Revised Oil Pressure Sending Unit for 2003-2016 Subaru Engines

The AERA Technical Committee offers the following information regarding a revised, improved oil pressure sending unit for 2003-2016 Subaru engines. This information should be considered anytime the oiling system is being worked on for these engines.

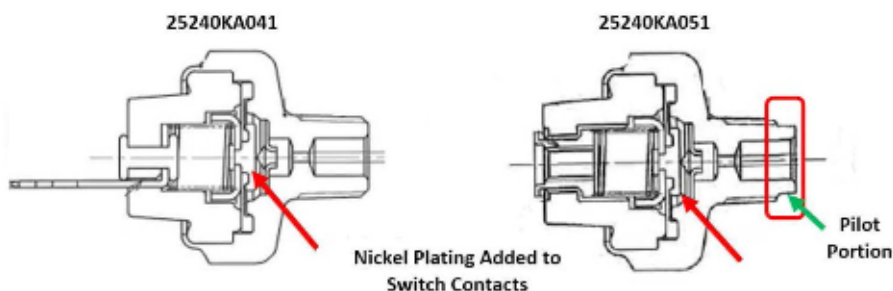
This Service Information bulletin announces a design change to the oil pressure switch assembly. Nickel plating has been applied to the internal switch contacts to enhance their durability and reduce the possibility of poor contact which could affect operation or cause improper illumination of the oil pressure warning lamp. A small pilot portion was added to the threaded area on p.n. 25240KA051 as shown in the illustration below.

The new p.n. **25240KA051** switch includes a pilot portion at the start of the threads as shown below.
